SS 469084 TBB Heater Hose cover heat shield improvement

Service Solution

Subject: Heater Hose covering at Wheel well

Models Affected: Type D buses

Figure 2

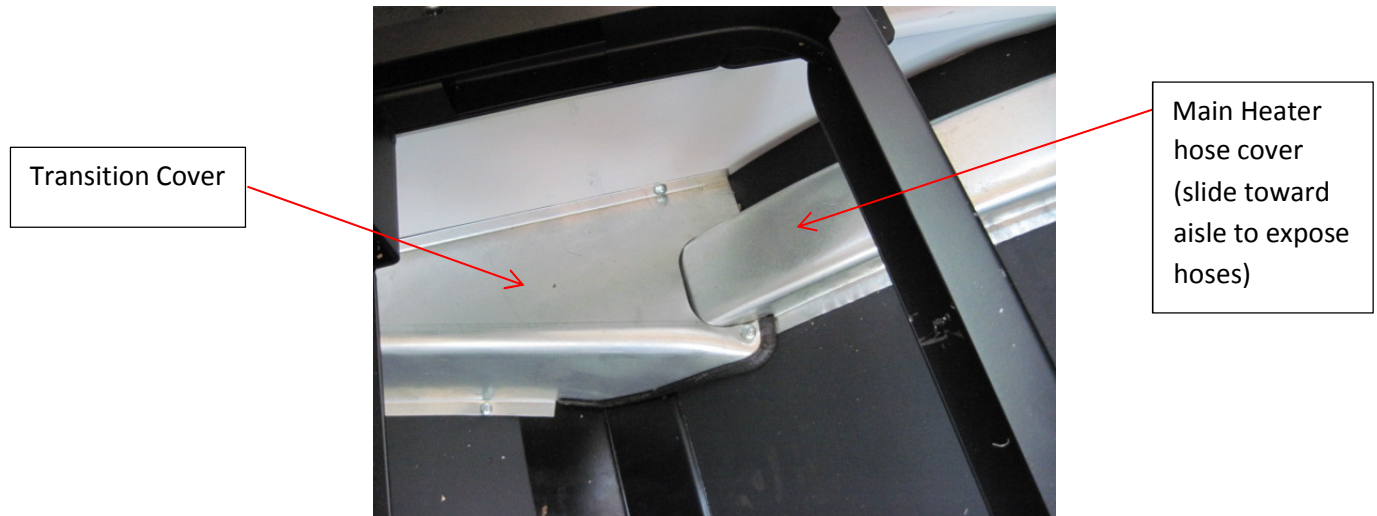
3. Once seat bottoms are removed, the metal covers are to be removed next. This requires removing the front and rear transition pieces using the screw gun. **Figure 2**

Figure 3

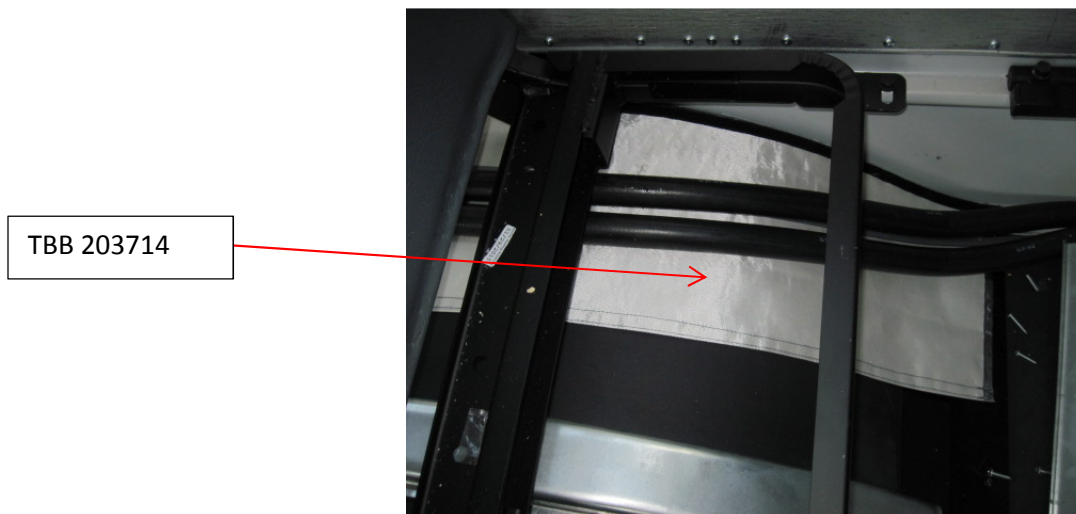
4. Once the front and rear transition covers are removed, the main cover can be moved off the hoses and pulled toward the center of the bus to keep out of the way.
5. The heat cover (TBB 203714) needs to be slid under the heater hoses as shown in **Figure 3**

6. Make sure that the hoses are centered in the cover and the cover is set so that it will cover the wheel well.
7. Wrap the covering around the hoses and attach Velcro.
8. Slide the metal covering back over the hoses and the covering. Make sure that all covering is under the metal cover.
